Written submission from CNSC Staff

Cameco Corporation, Rabbit Lake Operation

Application for the renewal of uranium
mine/mill licence for Rabbit Lake Operation

Subject / Objet: CNSC Staff Submission: Correction of Errors in CMD 23-H7, Licence Renewal, Cameco Corporation Rabbit Lake Operation

Figure 3.2: Maximum and average individual effective doses to RLO NEWs, 2013-2022*

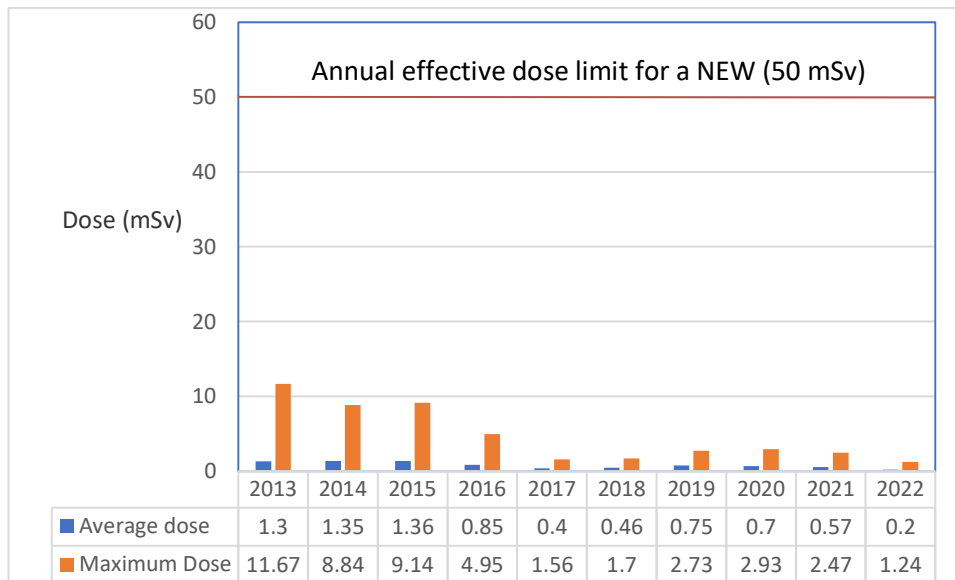
- On page 34, the Figure 3.2: “Maximum and average individual effective doses to RLO NEWs, 2013-2021” appears to have been partially cut off when the CMD was converted from WORD to PDF format. In addition, the years covered should be 2013-2022 (up to September 30, 2022). The correct graph and figure title are provided below:

Figure 3.4: Concentrations of radon in ambient air, 2013-2021

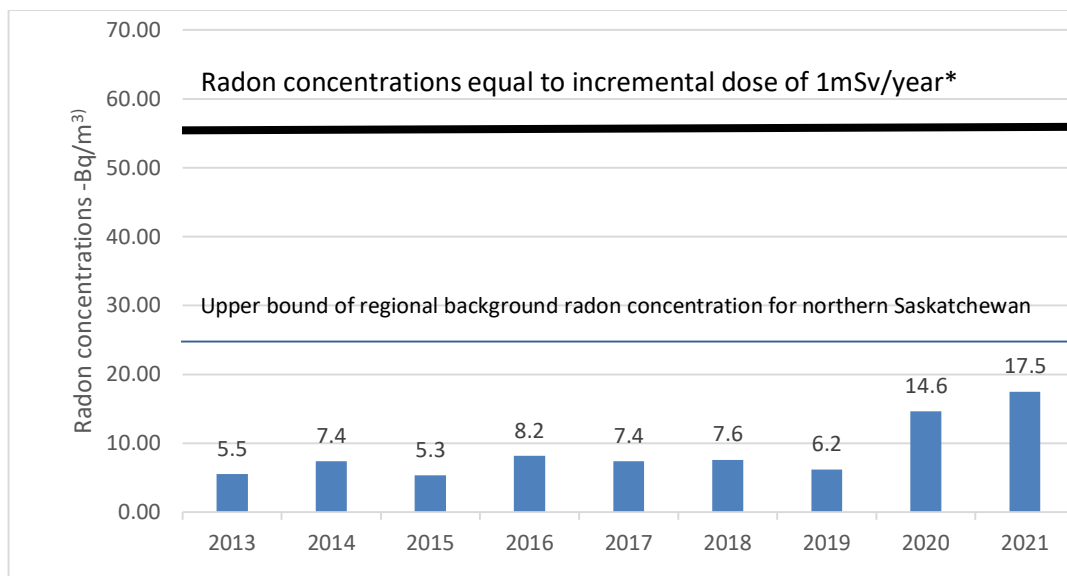
- On pages 49 and 50 of CNSC staff’s CMD, figures 3.4 and 3.5 were interchanged and labelled with the incorrect limits. Below are the corrected figures with the proper limits included:

*Upper-bound of the incremental dose of 1 mSv per year above background (i.e., an incremental radon concentration of 30 Bq/m³ above natural background) based on ICRP Publication 115. Values are calculated as geometric means.
